DEPARTMENT OF THE AIR FORCE  
HEADQUARTERS 377TH AIR BASE WING (AFMC)

Attachment:  
February 8, 2012 FFOR Excavation and Step-Out Conflicts, Addendum to IM WP, BFF,  
March 2011

**Subject: FFOR Excavation and Step-Out Conflicts  
Addendum to Interim Measures Work Plan, Bulk Fuels Facility Spill, March 2011  
Solid Waste Management Units ST-106 and SS-111  
Kirtland Air Force Base, New Mexico**

FIGURE 3

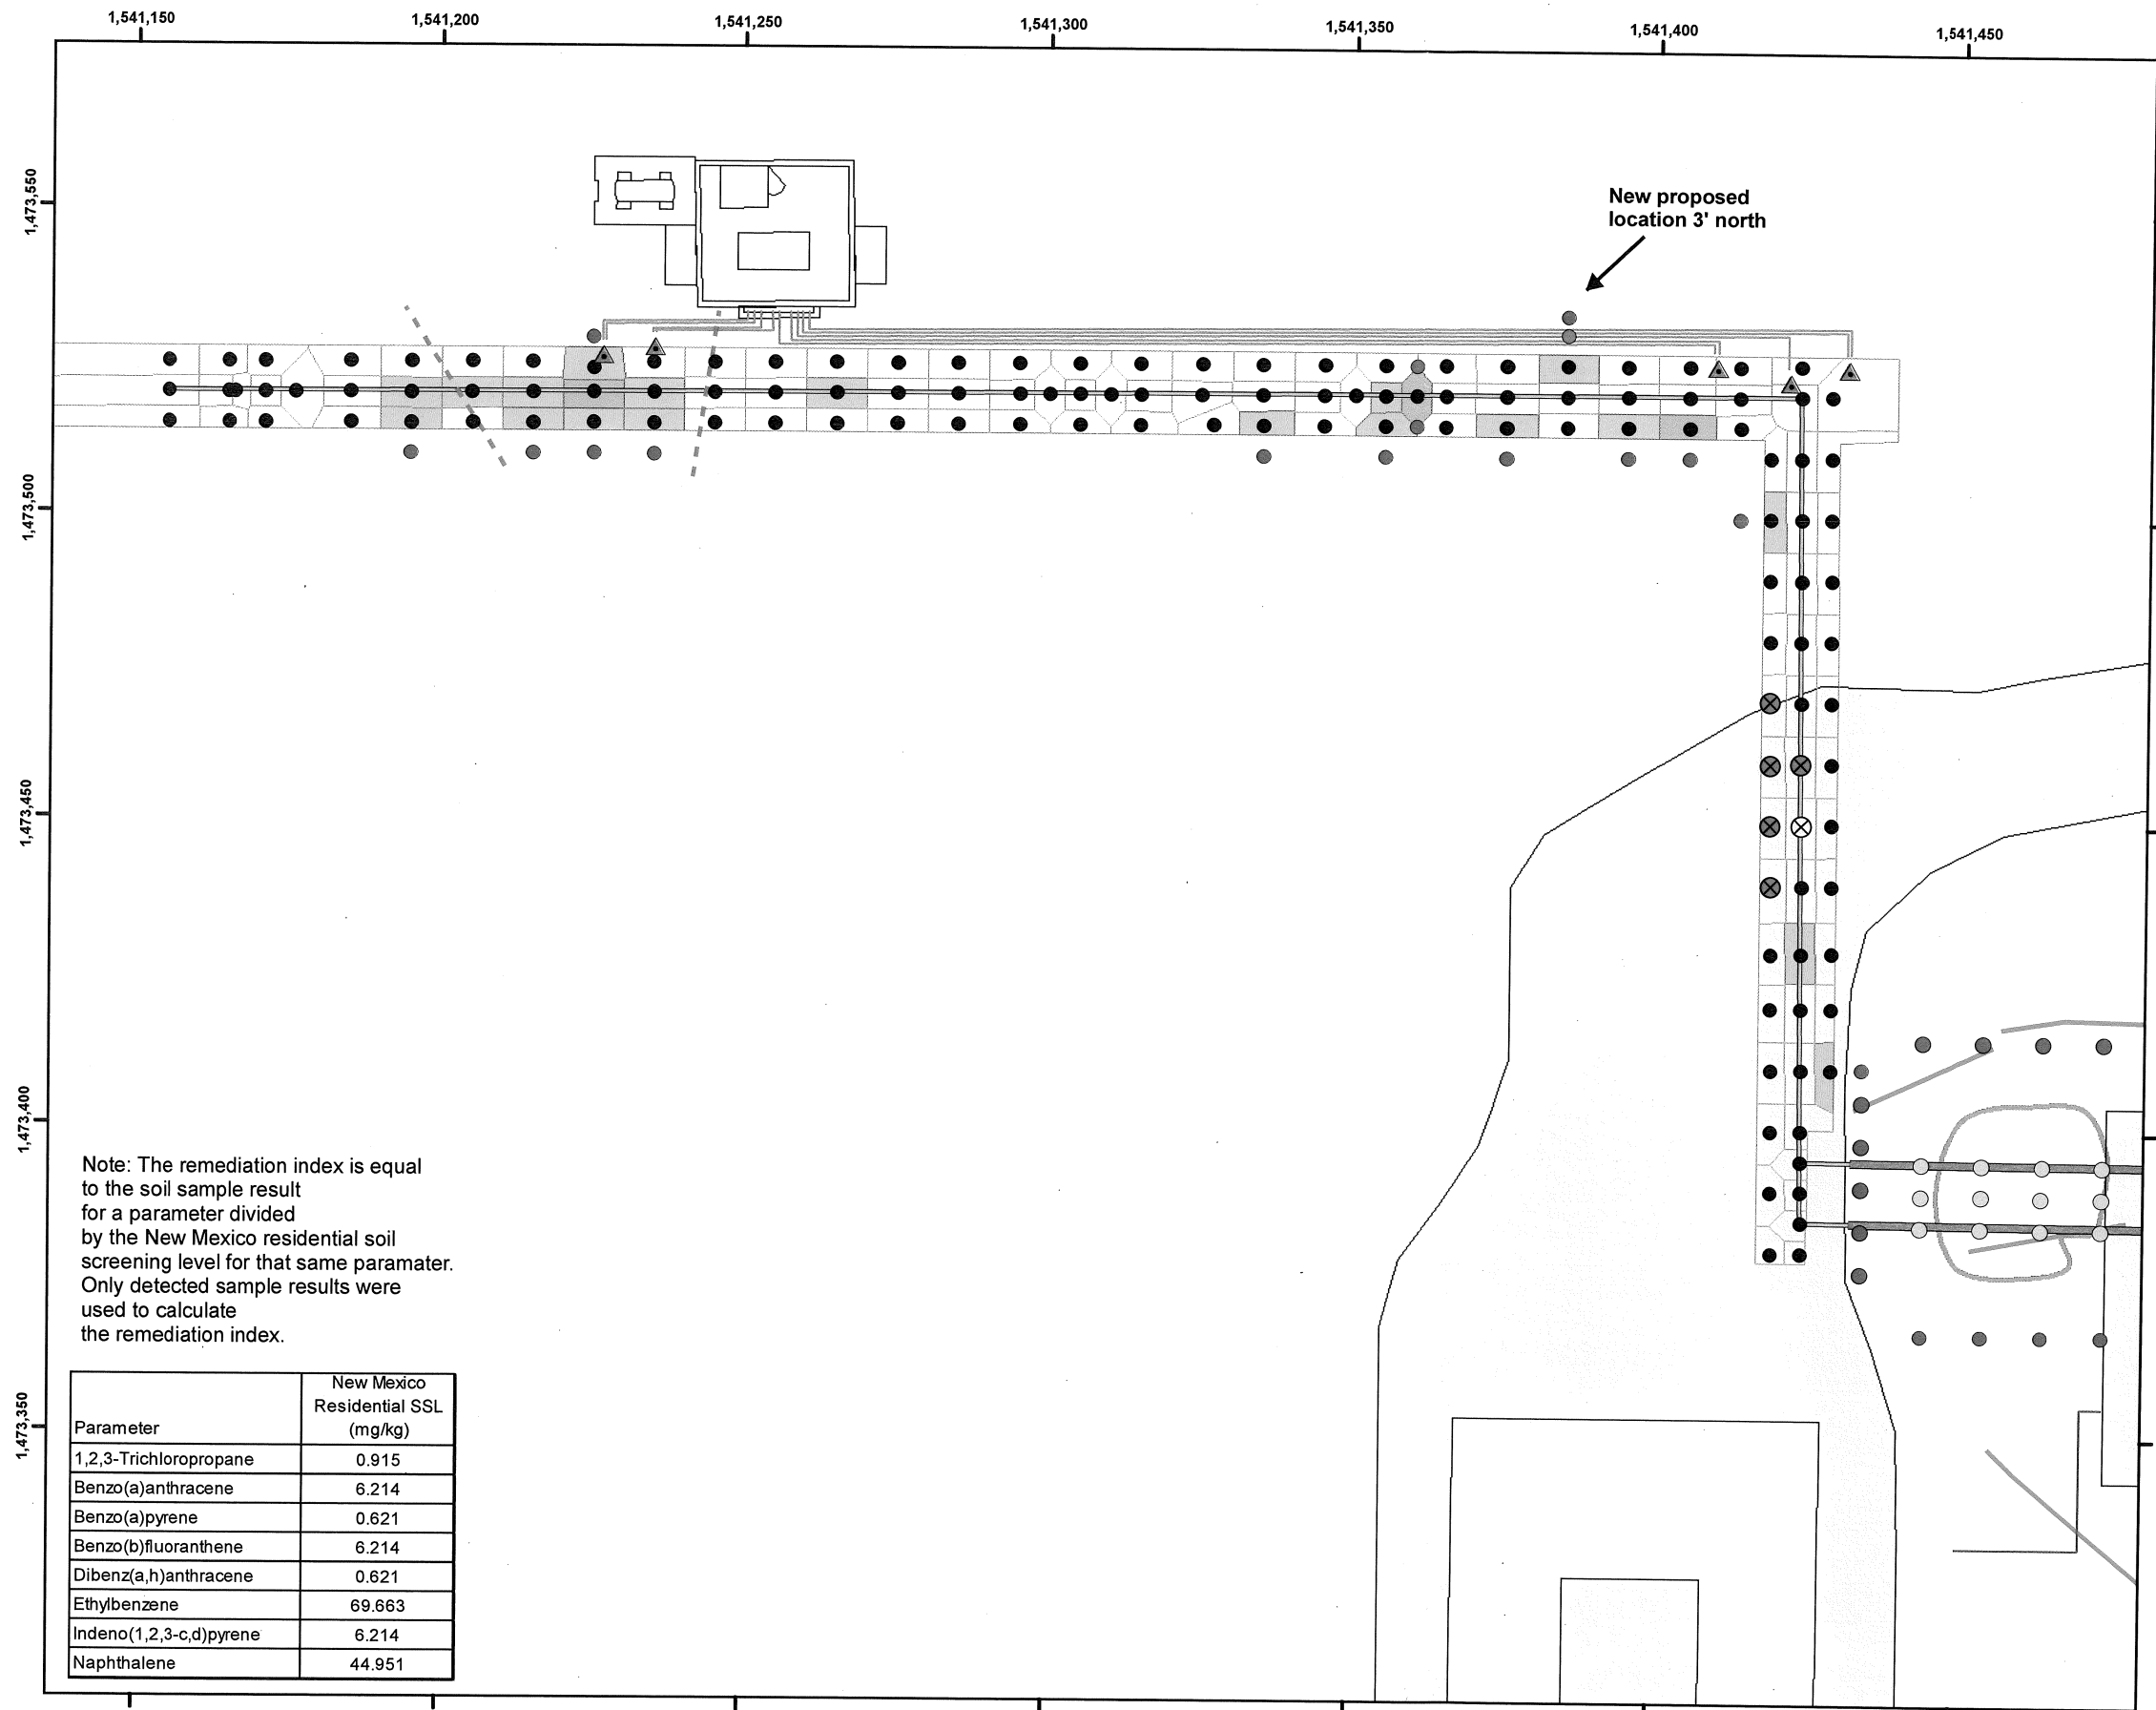
Following the initial soil investigation, Shaw identified sixteen locations where step-out samples were necessary to delineate exceedance zones. In November, 2011 these locations were surveyed and marked, and a utility located survey was carried out. It was established that there is one location where a proposed step-out sample is in conflict with existing underground utilities (Figure 3). The proposed location for this step-out places it directly above infrastructure that links soil vapor extraction wells to a soil vapor extraction system. Advancing this borehole would not only shut down, and cause damage to the SVE system at the FFOR, but could potentially release combustible hydrocarbon vapors. Shaw proposes the following steps to collect the step-out without impacting the SVE system:

1. Shaw will move the proposed step-out location 3 ft to the north.
2. During excavation, Shaw will hand excavate around the SVE conduits, and will develop an excavation plan to minimize the possibility of damaging this infrastructure.
